HISTORIC AND DESIGN REVIEW COMMISSION

HDRC CASE NO:	2017-375
ADDRESS:	1918 W MAGNOLIA AVE
LEGAL DESCRIPTION:	NCB 1961 BLK 9 LOT 22
ZONING:	R-6 H
CITY COUNCIL DIST.:	7
DISTRICT:	Monticello Park Historic District
APPLICANT:	Bob Bradley
OWNER:	Emily Gorman
TYPE OF WORK:	Construction of a front porch, installation of a new gutter system, exterior modifications

**Historic and Design Review Commission
Design Review Committee
Report & Recommendation**

HDRC Case# 2017-273

1918 WEST MAGNOLIA AVENUE

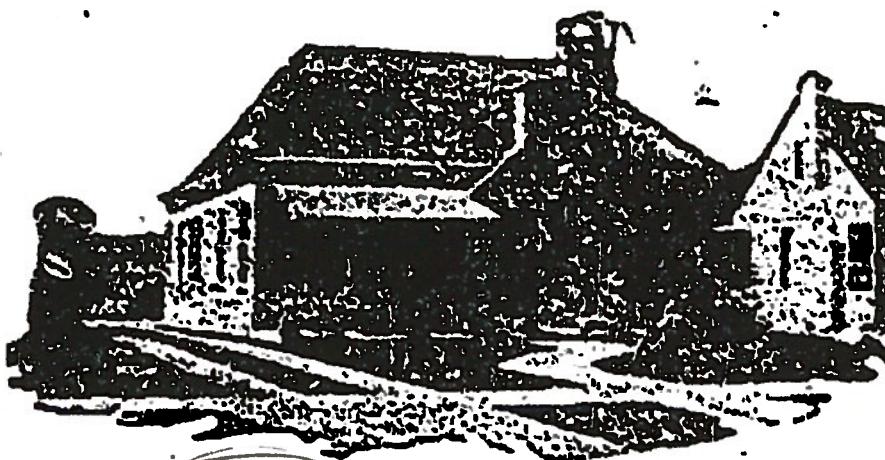
- b. The applicant met with the Design Review Committee (DRC) on July 11, 2017. The applicant provided an archival newspaper image of the primary structure from the 1920s that showed that the structure originally featured an awning-like structure on the west side of the front façade. This image is included in the exhibits. The DRC stated that with this evidence, a porch that covered this portion of the façade was acceptable for the style of the structure. The applicant also proposed a canopy structure above the front door entrance that would provide shade and rain protection. The DRC recommended exploring a curved arch option, preferably inset within the existing arched doorway opening, to respond to the character defining archway. The DRC offered several installation options that may be appropriate, with an emphasis on reversibility. The applicant also proposed a new front step on the existing concrete slab, as well as a trellis-like columnar structure for the porch supports. The DRC was favorable of both of these approaches based on the style and materiality proposed. The DRC stated that the new step should be as minimal as possible, about 6" in height and limited in width, to respond to existing features without introducing a dramatic new element.

COMMENTS/CONCERNS: Supplied evidence of porch/awning; Hood that goes over door to project that fits in the arch, won't change chimney mass. Is reversible.

GORMAN RESIDENCE
1918 W. MAGNOHA
SATX. 78201
NEW FT. PORCH COVERINGS

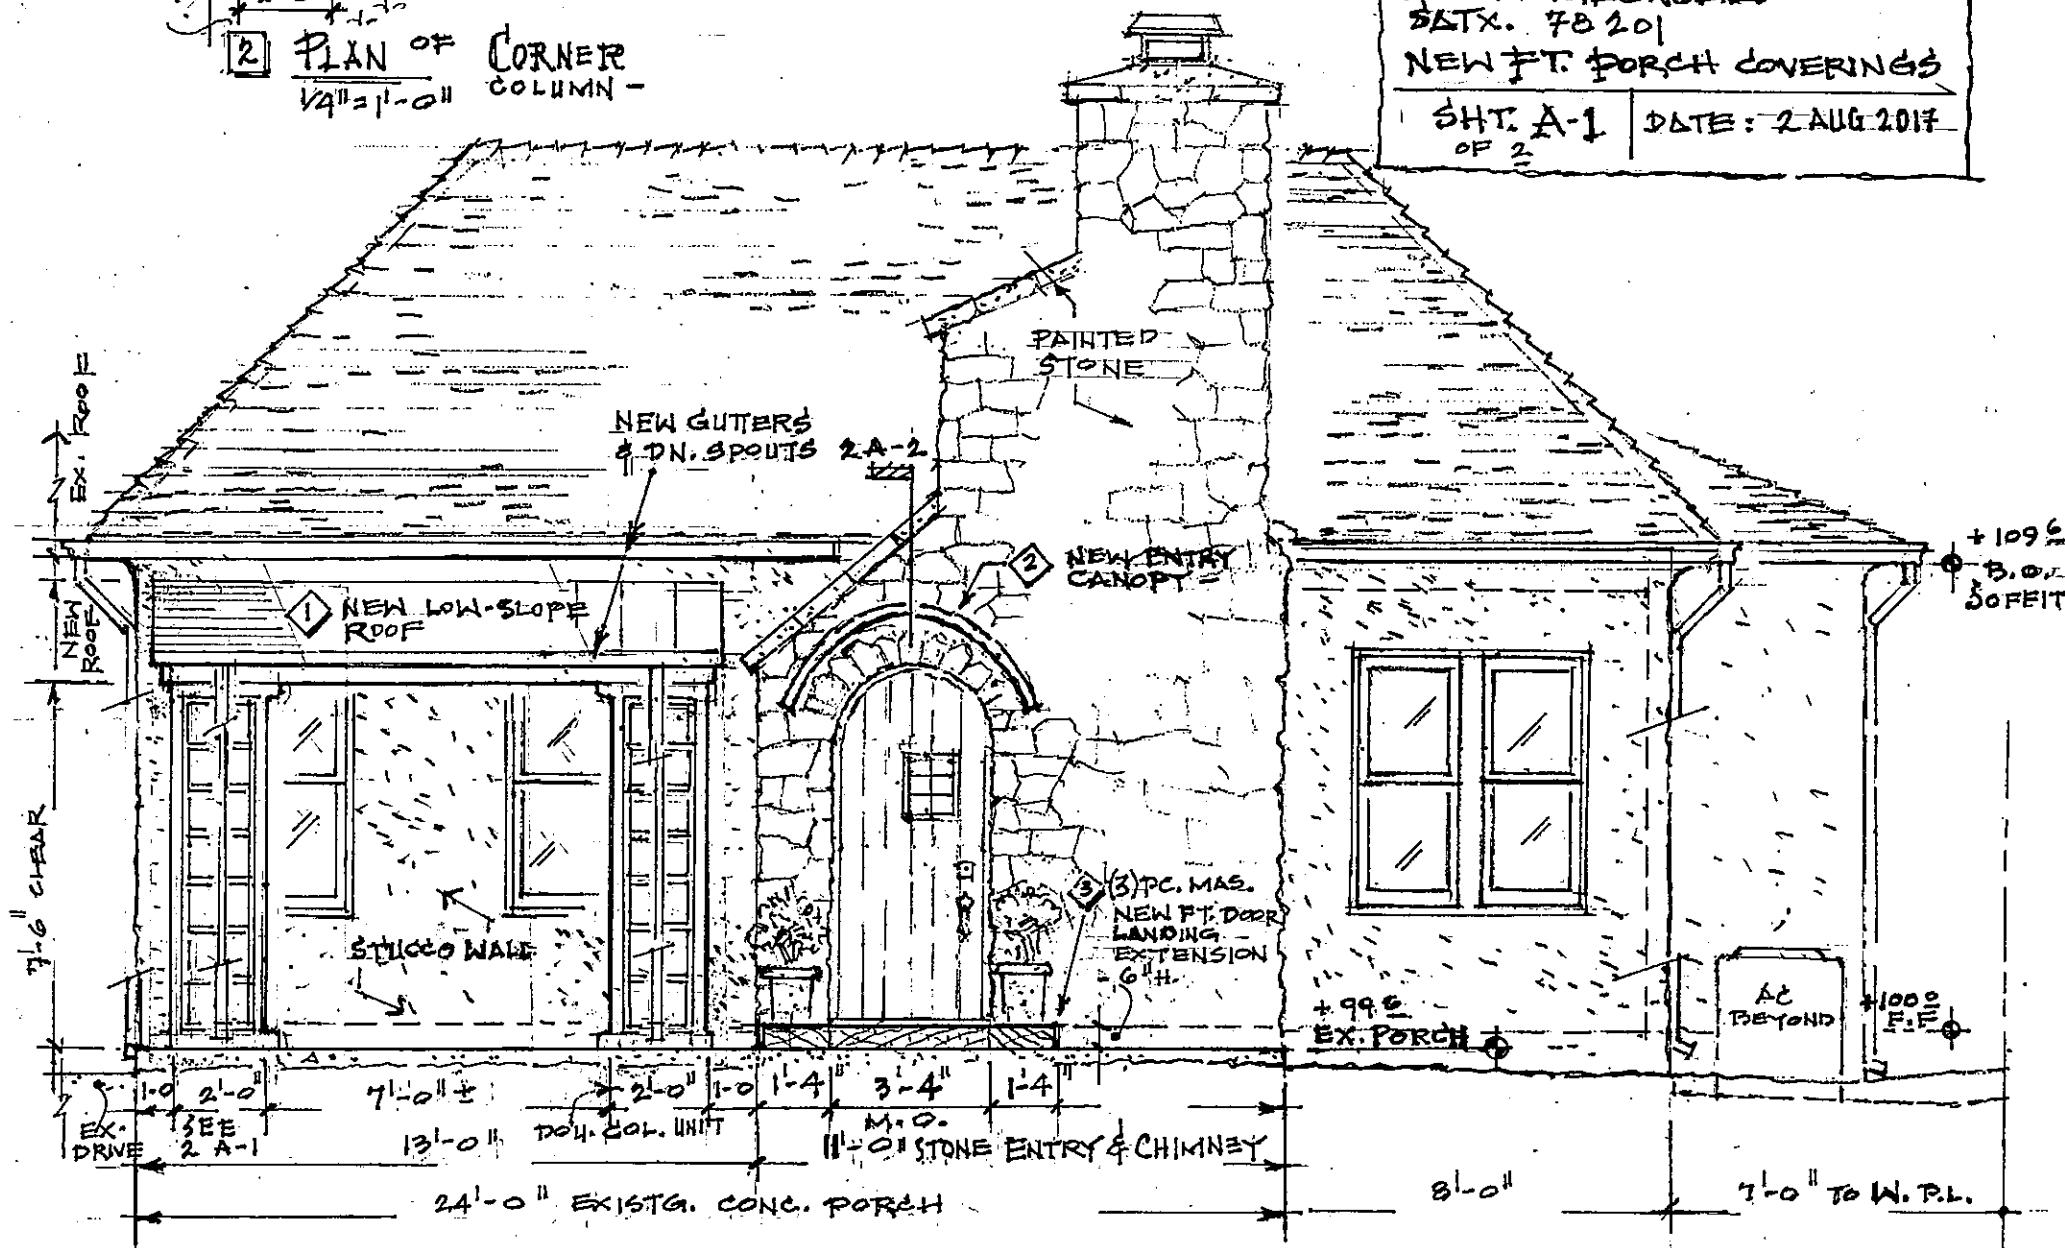
- c. FRONT PORCH: LOCATION – The applicant has proposed to install a new roof that extends from the west front roofline to an inch west of the chimney to create a new front porch. The porch will measure approximately 11 feet in length, and will extend the depth of the existing concrete decking, which measures approximately 8 feet. The new roof will have a pitch of approximately 1.5 over 12. According to Guideline 7.A.i, new porches should not be added where historically present. The applicant has provided evidence that an awning or porch structure has existed historically on this property. The proposal also does not conceal any portion of the character defining front chimney. Staff finds the proposal consistent with the Guidelines.

- d. FRONT PORCH: MATERIALS AND DESIGN – The new porch roof will be supported by pairs of painted wood columns with a trellis constructed with thin painted wood beams. The trellis will be covered with flowering jasmine. The proposed roof will be covered with composition shingles to match the existing material of the

low pitch roof a la newspaper image, could drain there from existing roof. Columns: ok for trellis/double column.

Look at materials, gauge for stiff ^{curve} ~~edges~~ to avoid brackets, regarding the door canopy. ~~xxxxxxxxxxxx~~. Maybe standing seam or bent plate. Curve will give it strength. Fits into arch and project out - most minimal solution.
Porch: 2, maybe 3 columns, depending on window spacing.

Item 1, Staff recommends approval of the new front porch installation based on findings a through d.

ELEVATION AT ARCHED ENTRY

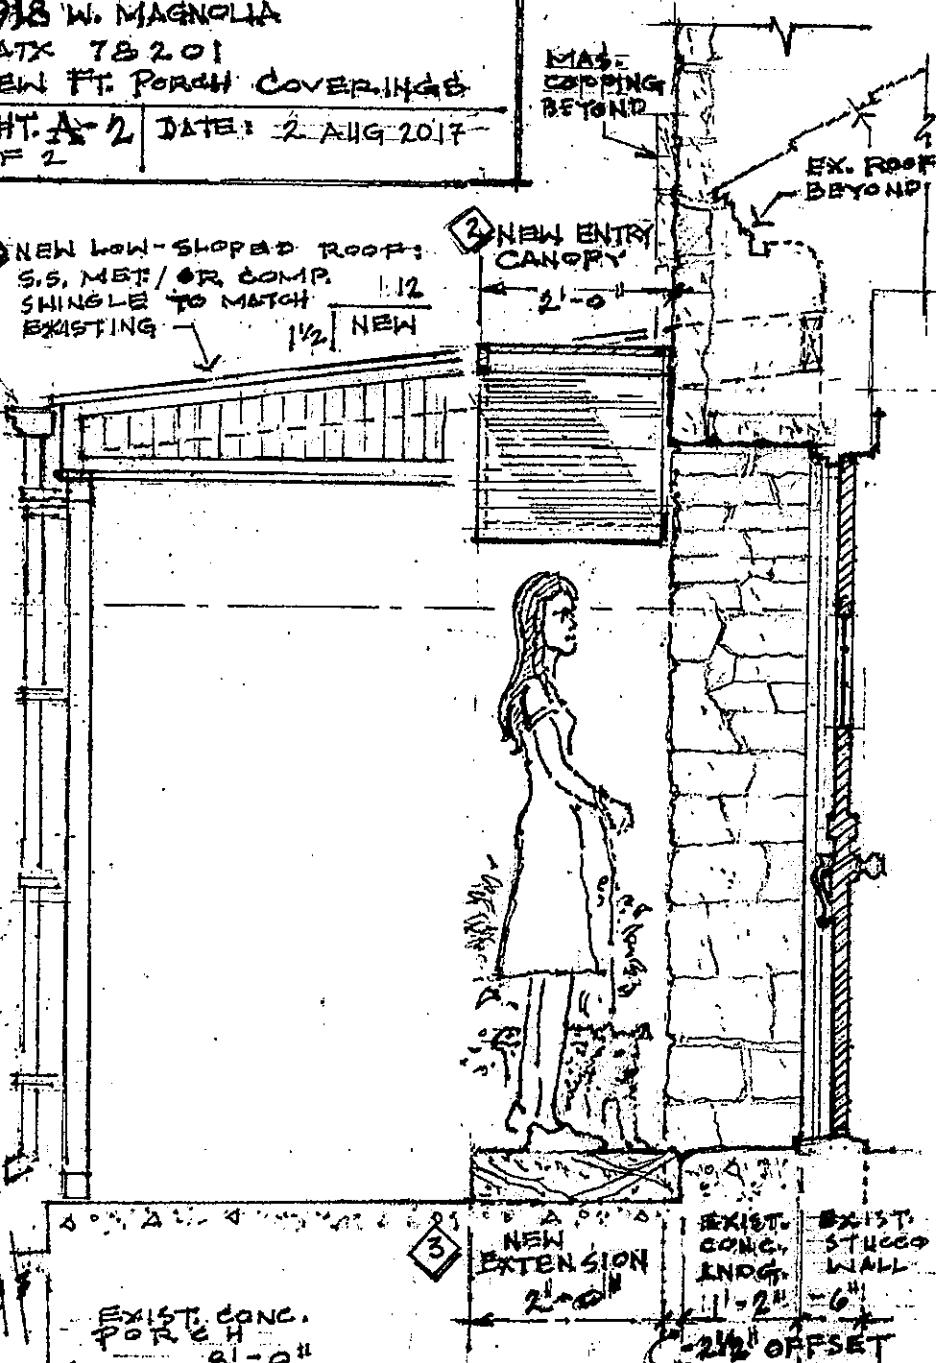
- e. FRONT DOOR CANOPY – The applicant has proposed to install an arched canopy above the existing arched doorway. The canopy will be approximately 3" in thickness and be made of a UV resistant fabric awning material or a lightweight metal in a color that complements the gray and blue color scheme of the existing home. The canopy will project approximately 2'-6" from the front façade to provide shade and rain protection. According to the Historic Design Guidelines, new elements should not obscure character defining elements, nor convey a false sense of history. This approach does neither and will be installed in a way that is reversible. The proposal responds to the existing geometry of the architecture and is a minimal element that will not detract from the significance of the historic material. Staff finds the proposal consistent with the Guidelines.

Depth of canopy to be determined, but will help solve backsplash issue. Metal OK.

Item 2, Staff recommends approval of the front door canopy installation based on findings a, b, and e with the following stipulations:

- i. That the applicant submits final material specifications to staff for approval.
- ii. That the applicant final detail drawings showing how the canopy will be installed.
